Regarding Development Plan Application # 201504270021

Thank you for your letter summarizing the City's Departmental review of our development plan application for the Broadway and Park Apartment Homes proposed in Grove City's town center. Our responses to the comments provided by the various City Departments are as follows:

BROADWAY & PARK APARTMENT HOMES
Grove City, Ohio

DEVELOPMENT PLANS

SITE DEVELOPMENT PLAN

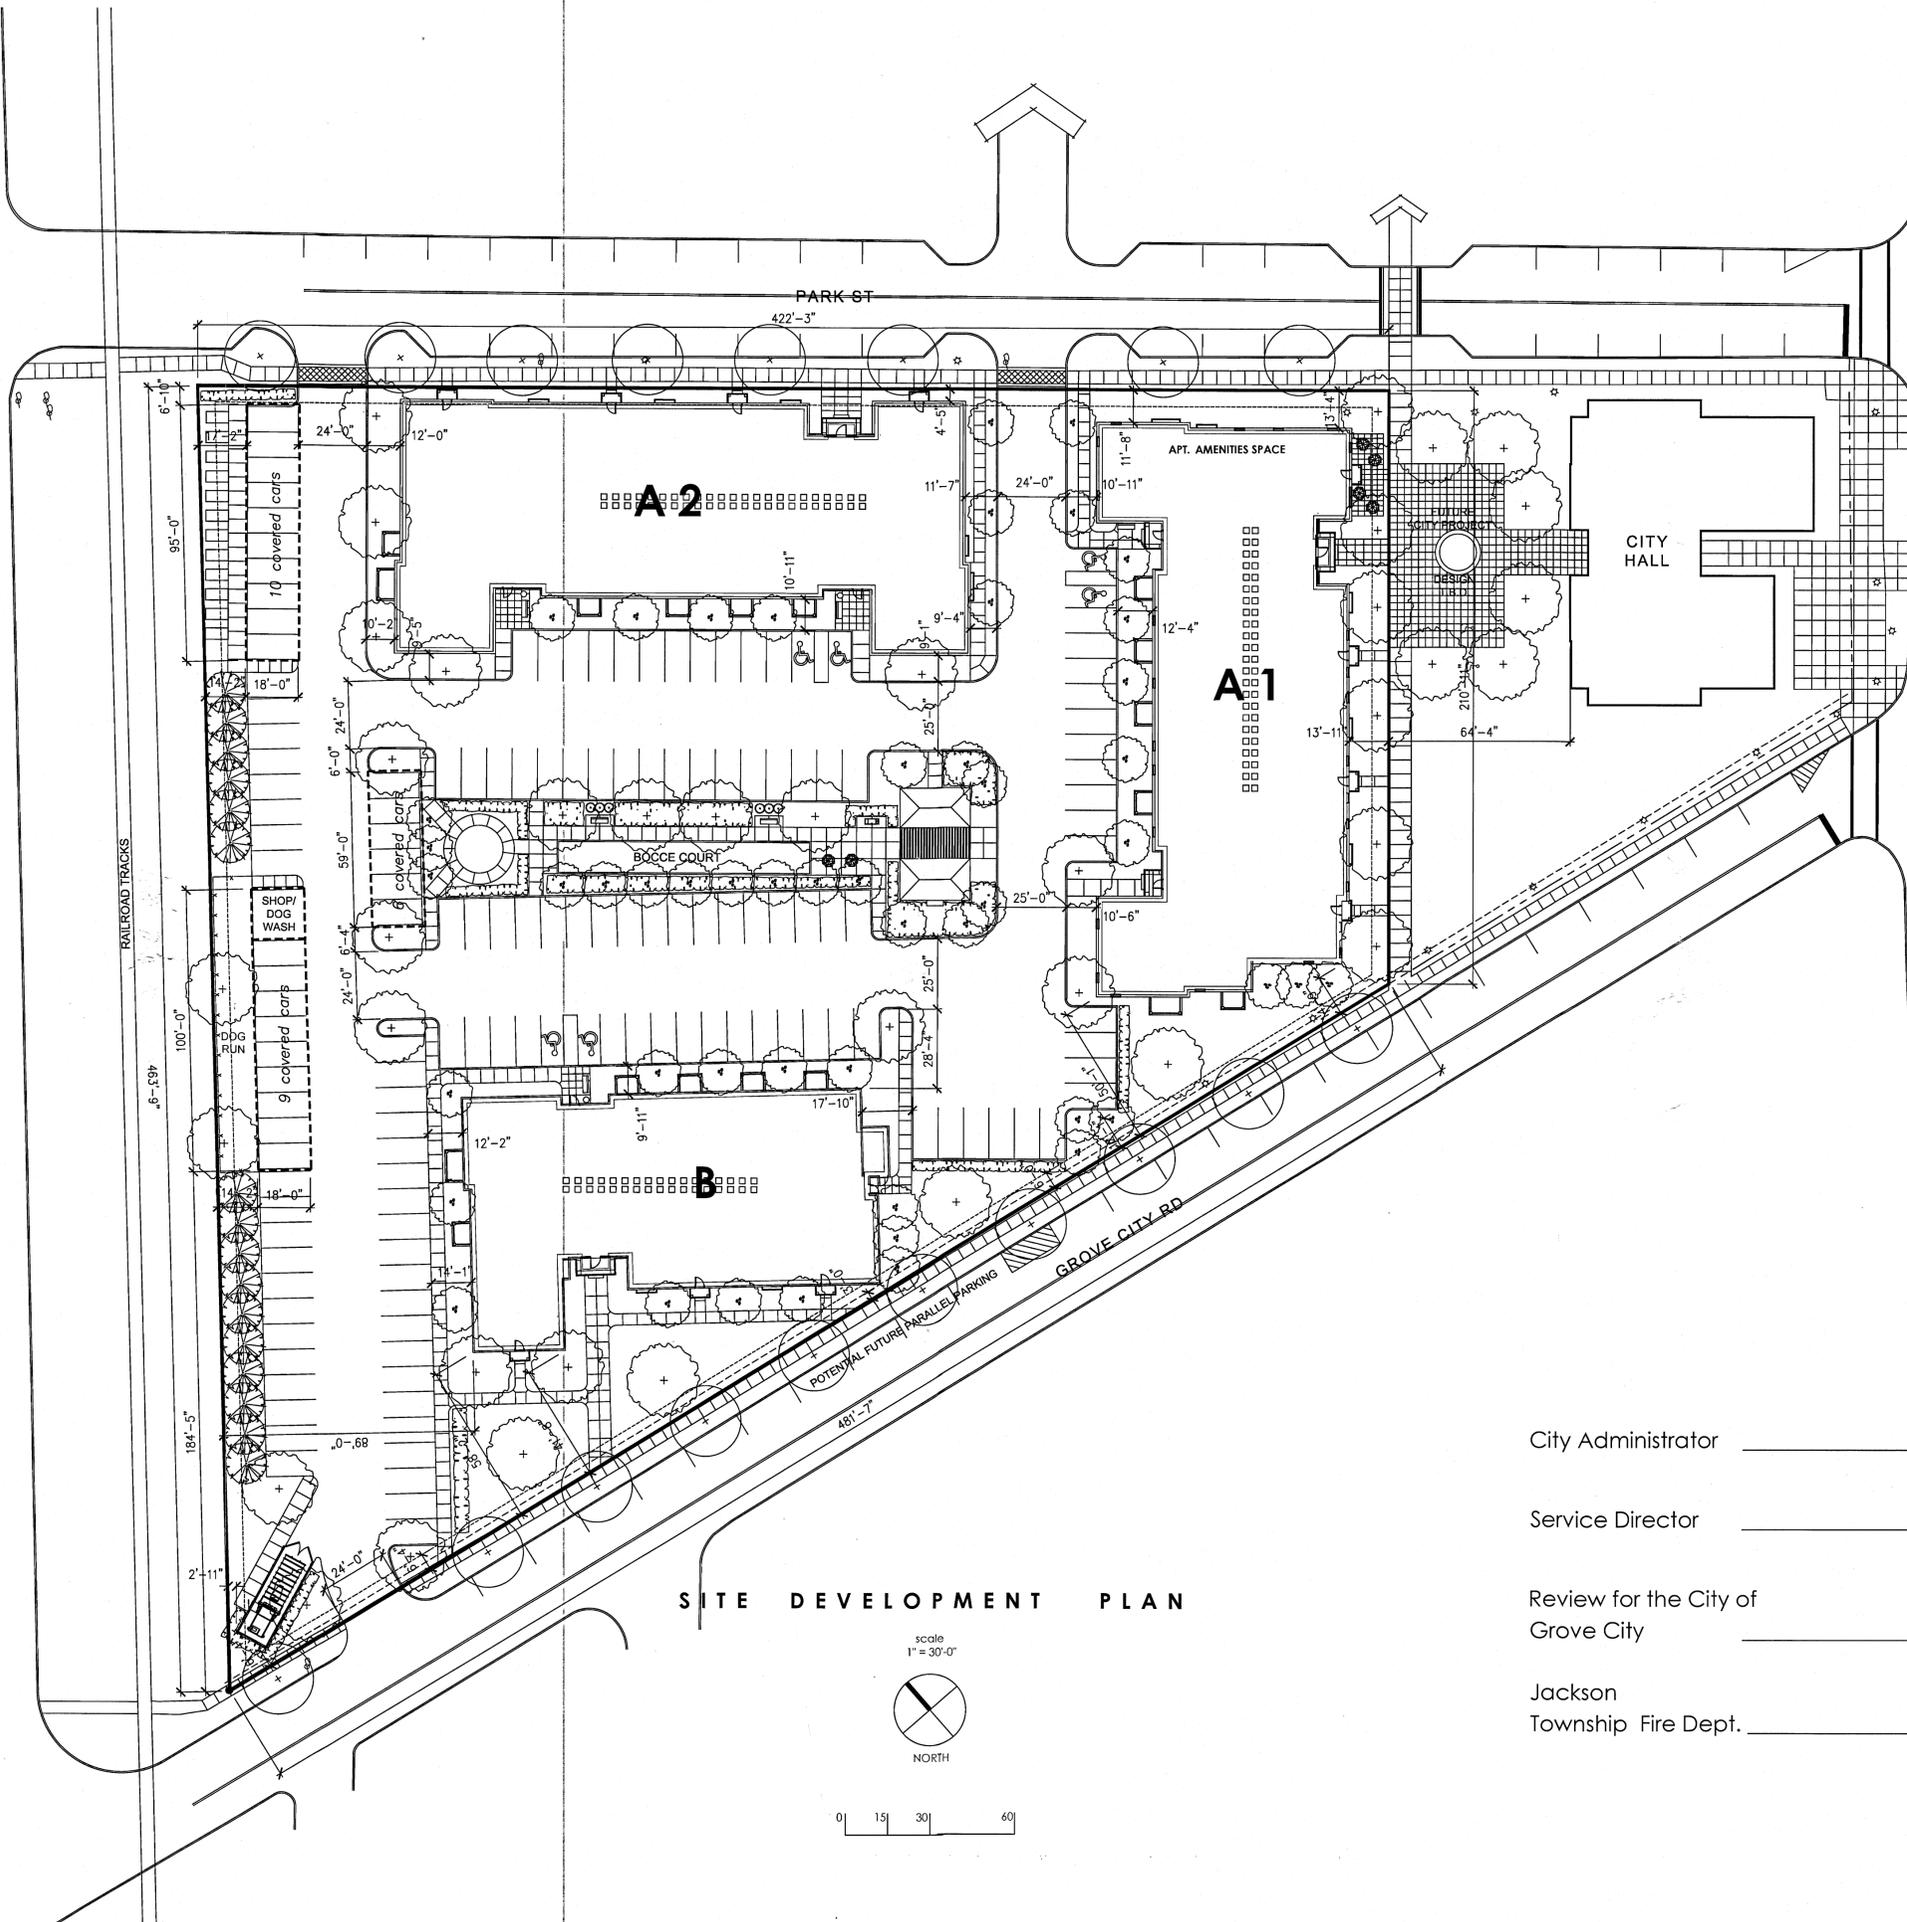
1. All proposed building and parking lot setbacks should be noted on sheet AS1.

2. The east-most parking space east of Building B (see image to the right) should be eliminated to increase the separation between the parking lot and the sidewalk along Grove City Road.

RESPONSE: Building Setbacks have been noted on Sheet AS1.

RESPONSE: This parking has been reconfigured to meet the setback requirements.

1 COMPACTOR / ENCLOSURE PLAN
 1/4" = 1'-0"

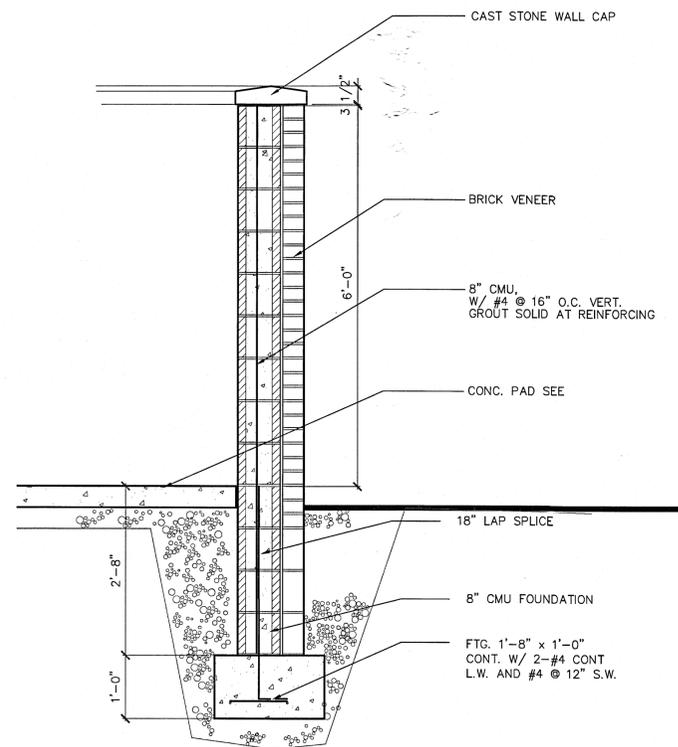
11. Details and elevations should be submitted for the proposed trash enclosure. The enclosure should be finished in brick to match the residential structures with stained wood gates.

RESPONSE: Architectural details of the trash enclosure have been added.

FIRETRUCK AUTOTURN EXHIBIT
1" = 100'

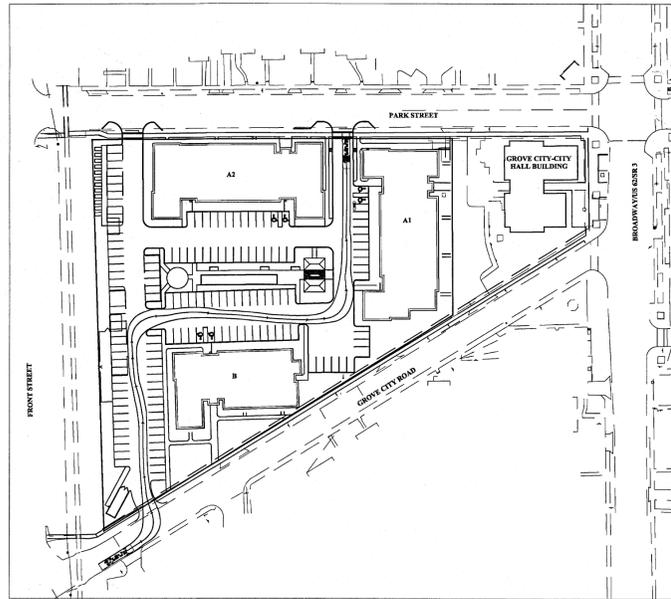
23. The ladder truck must be able to access the parking lot without running over curbs and without trees scraping the sides of the truck. Please show a plan with ladder truck maneuverability through the parking lot.

RESPONSE: See the attached Site Utilities Plan for details. In addition, it should be noted that a ladder truck can access Buildings A2 from Park Street and Building B from Grove City Road and a ladder truck can access building A1 from the existing driveway to the west of City Hall, from Park Street or from Grove City Road.

GROVE CITY, FRANKLIN COUNTY, OHIO
CONCEPT SITE UTILITY PLAN
FOR
GROVE CITY APARTMENTS

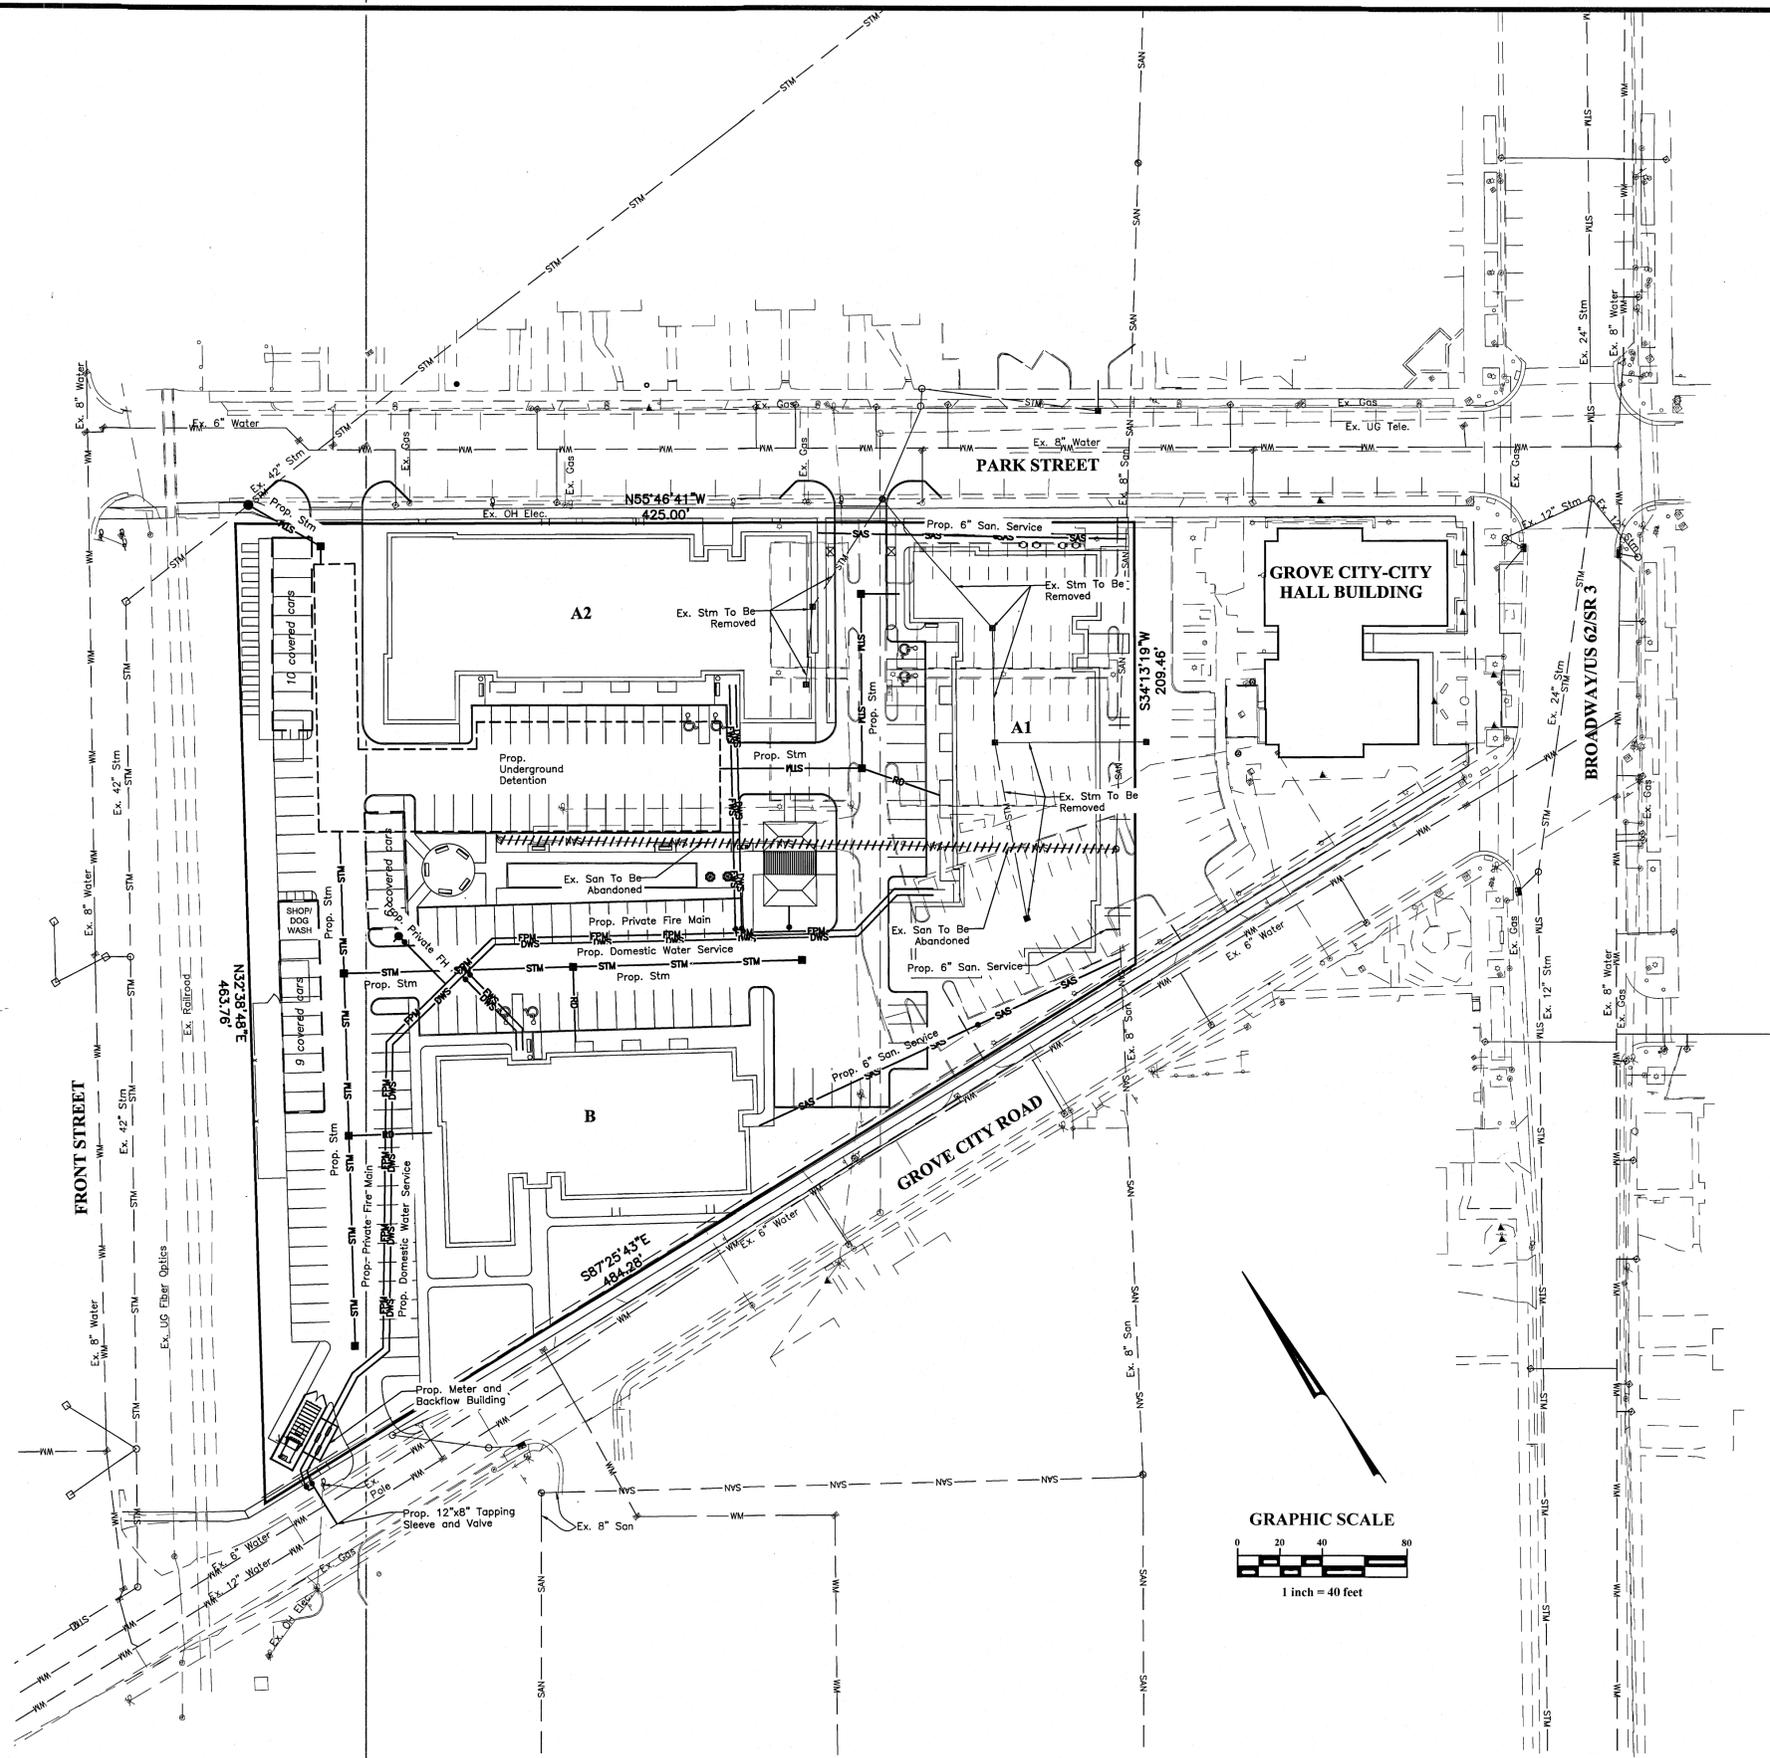
19. Building A1 is shown over an existing 8" sanitary main. This main should be re-routed as necessary to provide sanitary service to the project. Any sanitary mains on the site will need to be in recorded easements.

20. Proposed storm water management for this project needs to be provided.

21. Show all proposed utility services (sanitary, water, storm, etc.) on the site plan.

RESPONSE: The existing 8" sanitary main shall be abandoned in place and removed where in conflict with building foundations or proposed utilities. New 6" sanitary service shall be provided to each new building. See the attached Site Utilities Plan for details.

RESPONSE: See the attached Site Utilities Plan for details.

RESPONSE: See the attached Site Utilities Plan for updates.
